Province of British Columbia  
MINISTRY OF ENERGY, MINES  
AND PETROLEUM RESOURCES  
Mining & Minerals Division  
Report of Inspector of Mines  
(Issued pursuant to Section 15 of the Mines Act)

Inspection No.: 12418  
File: 18070-02  
Mine No: 1500021  
Permit No: Q-11-001  
Emp/Cont: 0 / 0  
Orders H&S: 1 RECL:  
Stop Work:

NAME OF MINE	Red Lake Quarry	LOCALITY	50.933, -120.817, 092I/15W Tranquille
OWNER/OPERATOR	Absorbent Products Ltd.	ADDRESS	714 Sarcee ST. Kamloops BC V2H 1E7
MANAGER	Peter Aylen	AREAS INSPECTED	General site

Southern section of quarry ready  
for seeding

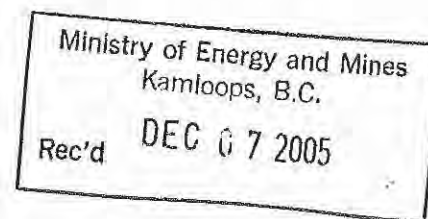
At the time of inspection, work was being carried out on the southern area of the quarry. The floor had been smoothed and prepared for seeding. Pit faces were found to be an acceptable height.

Shoulder barriers shall be provided on all travelways where the drop off is greater than 3 metres. The barriers shall be of appropriate thickness and height pursuant to 6.9.1 of the Code. To be remedied immediately.

A shoulder Barrier has been provided where the drop is greater than three meters. This barrier is made up of overburden and earth.
